CITY OF EL MIRAGE DEVELOPMENT APPLICATION FORM

Case No: PZ22-12-33 Date Received: 12/12/2022 PC Meeting: 1/24/2023 CC Meeting: 2/22/2023

TO: Alex Hayes, Withey Morris, PLC
FROM: Jose A. Macias, Senior Planner
 Development Services Department, Planning & Zoning
RE: PZ22-09-26 Agua Fria Commerce Site Plan Approval
DATE: January 24, 2023

TO: Jose Macias, Planner/GIS
FROM: Bryce Christo, P.E., Assistant City Engineer
SUBJECT: Agua Fria River RV, Boat & Storage – Development Application Review
DATE: 01-17-23

CACTUS & AGUA FRIA RIVER RV, BOAT AND STORAGE CAMPUS STORAGE ELEVATIONS & PARK ENLARGEMENT

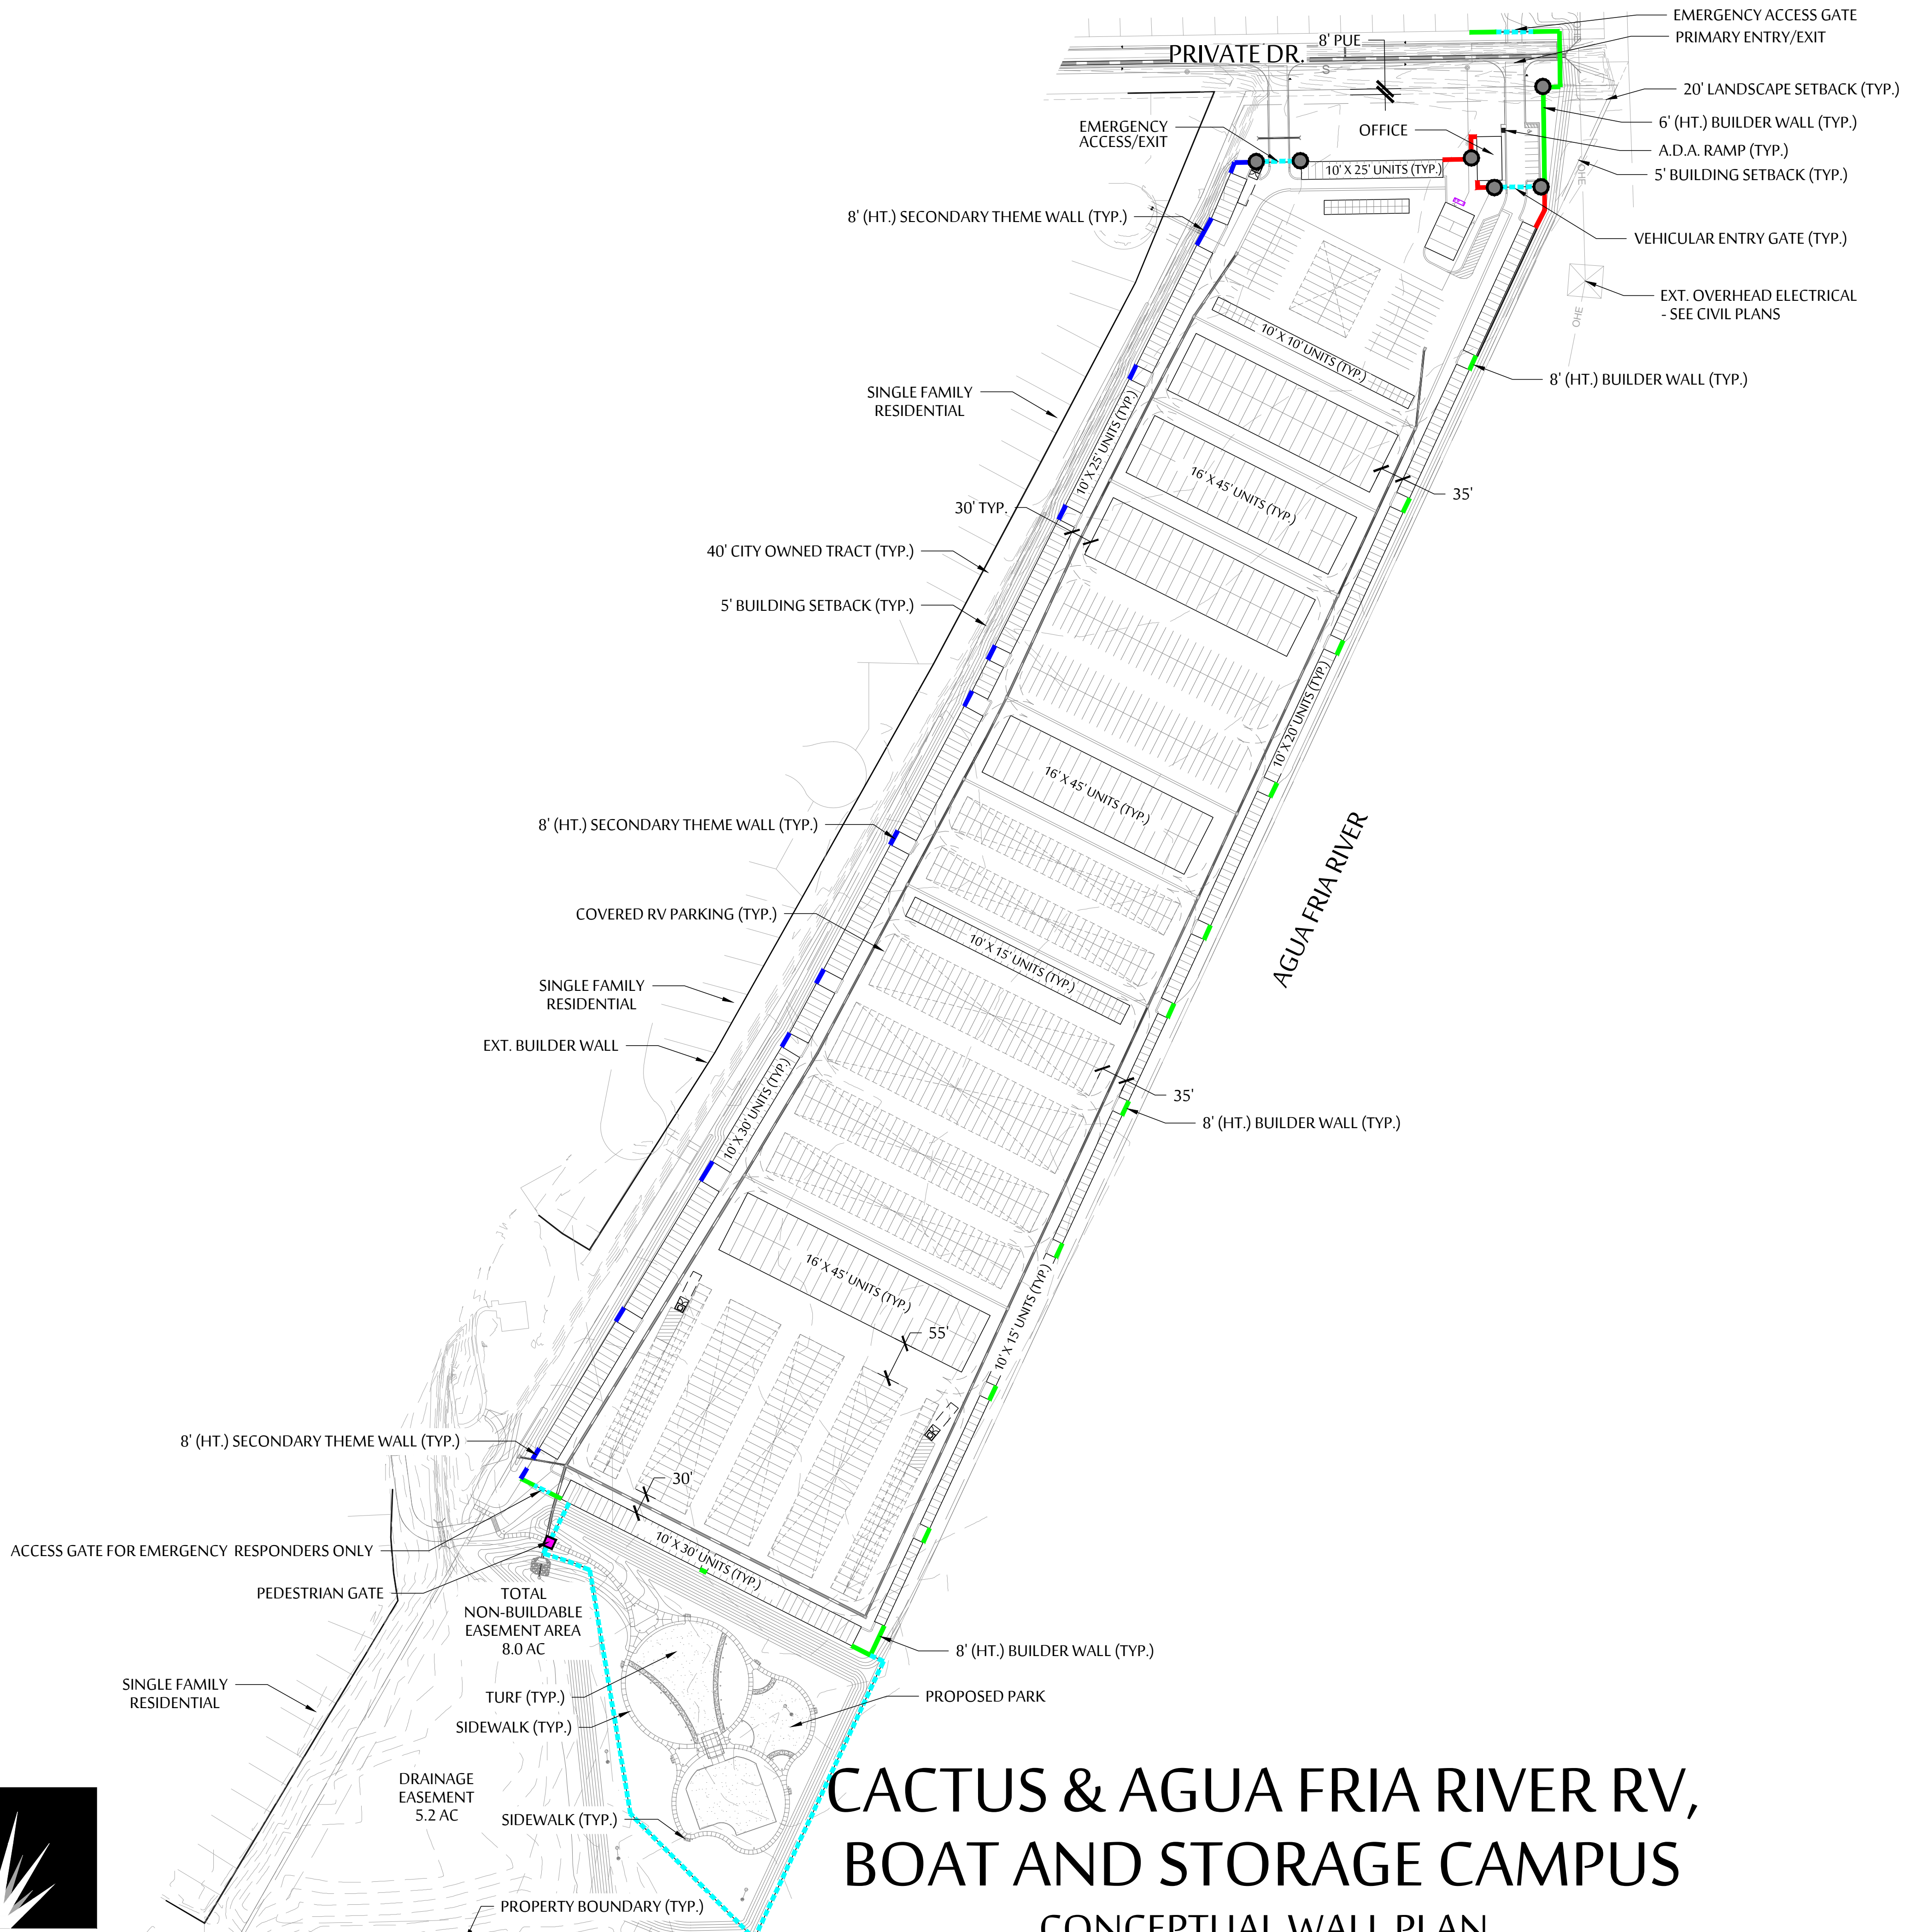
53. Storage Elevations & Park Enlargement – The views of the RV Storage from the cul-de-sac and easement show parked vehicles behind the trees but should these be buildings instead? Also, would you be able to see the buildings due to the height of the wall and elevation difference between Sundial IV and the RV Storage property?

CONCEPTUAL WALL PLAN

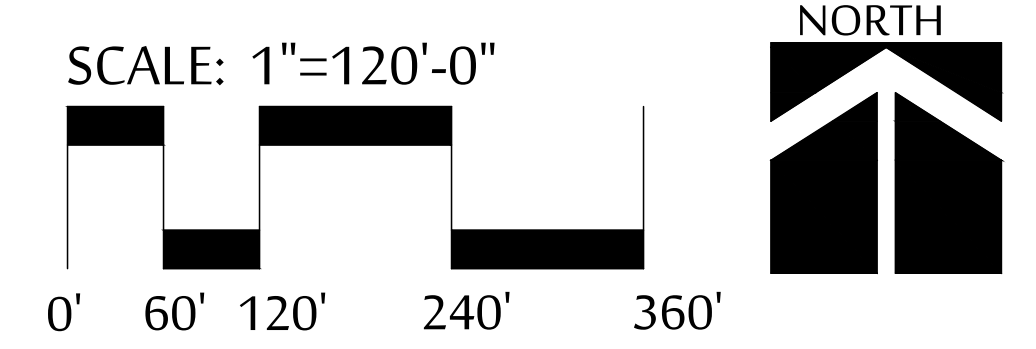
51. Irrigation plans will be required.
52. Preliminary Wall Plan - What is the spacing between the Builder Wall that runs along the south side of the property and Storage Building 15.

FRONT OFFICE ELEVATION

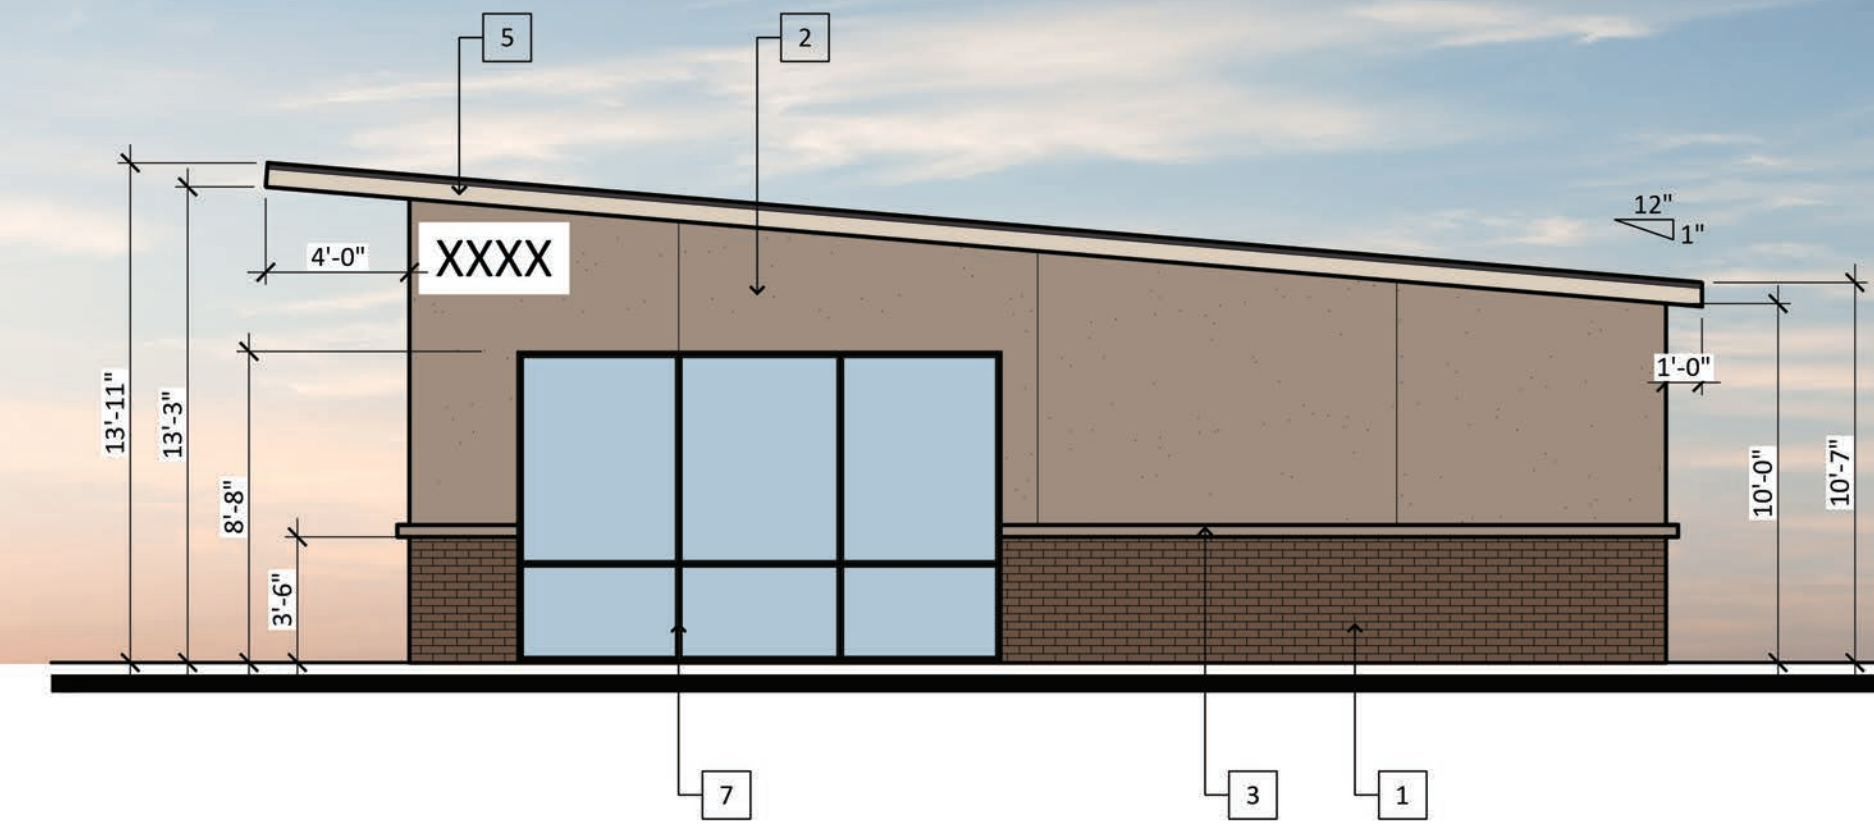
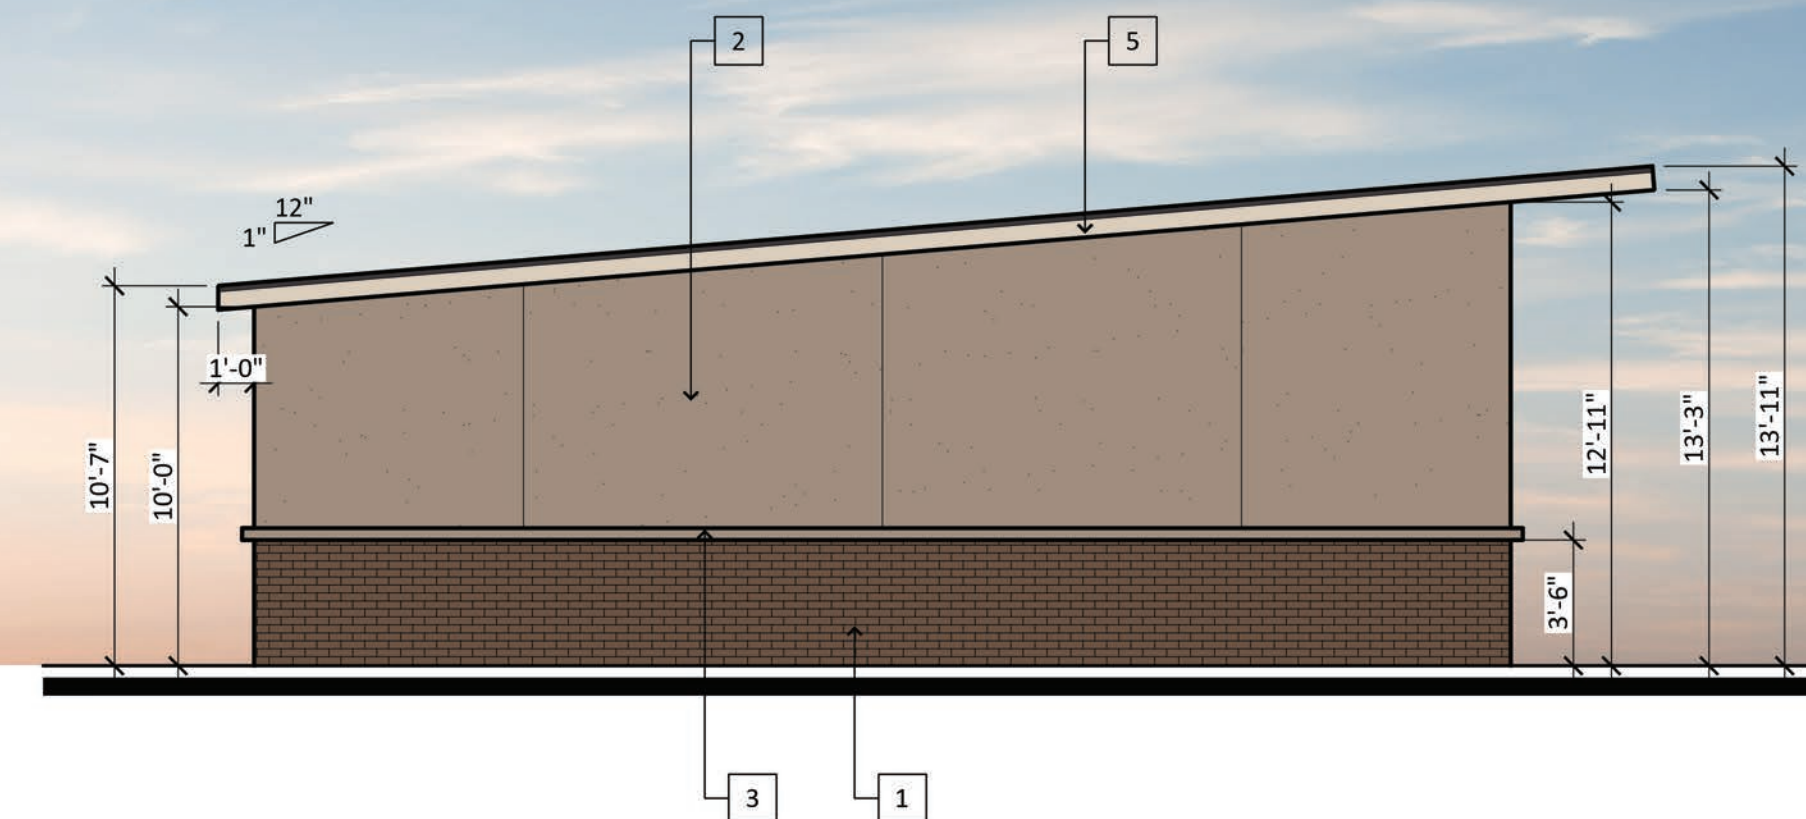
55. No elevation for the office was provided.
